Cassington Parish Council Responses to Submissions For Deadline 5 and Comments Related to the Issue-Specific Hearing 9th October, 2025

Applicant's Responses to other D4 Submissions and comments on Interested Parties' Responses to ExA's Second Written Questions (ExQ2) Submitted at D4 PINS Ref: EN010147 Document Ref: EN010147/APP/15.2

Figure 1. Proposed scaling back of the Botley West proposed solar arrays north of Cassington and Worton. Areas in red hatch are where solar arrays from the proposal are removed.

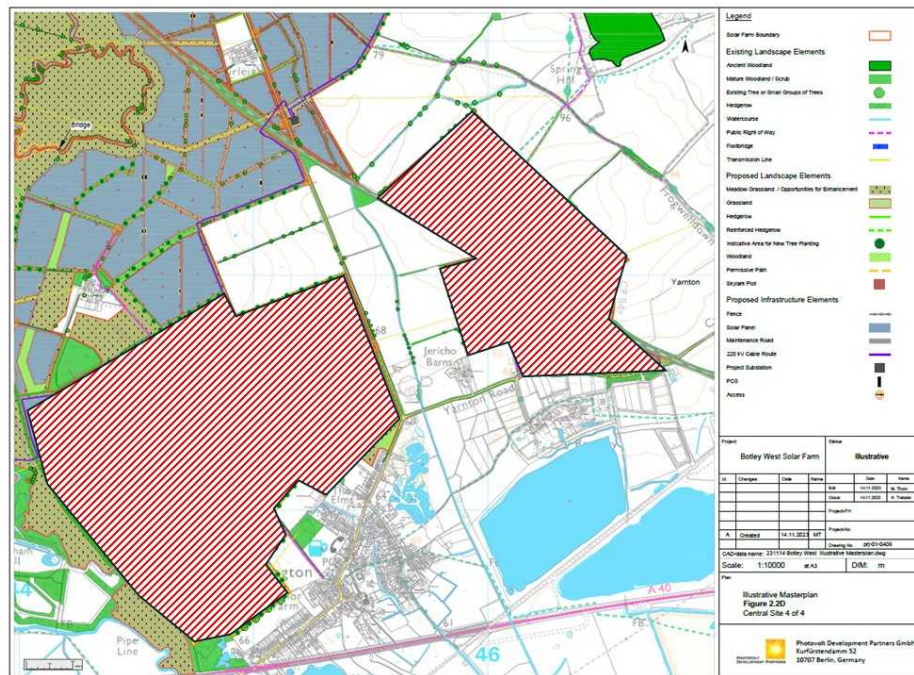
Cassington Parish Council are therefore proposing that either the Botley West proposal is rejected which remains both the Parish Council's and resident's favoured option, or it is scaled back from the north of the village to the summit of the hill contours that lie to the north of the village. A rough sketch of what this would look like is indicated in Figure 1 below.

This proposal has the advantage of moving the entire scheme back from Cassington village where we believe that it is far too close to dwellings in the village. This will help to preserve amenity of at least some of the public rights of way from Cassington and Worton. It also avoids issues around the potential alterations to local temperature that may occur as a result of conversion of solar energy to heat by the vast array of panels across the landscape. It also preserves some of the greenbelt and farmland that would otherwise be lost.
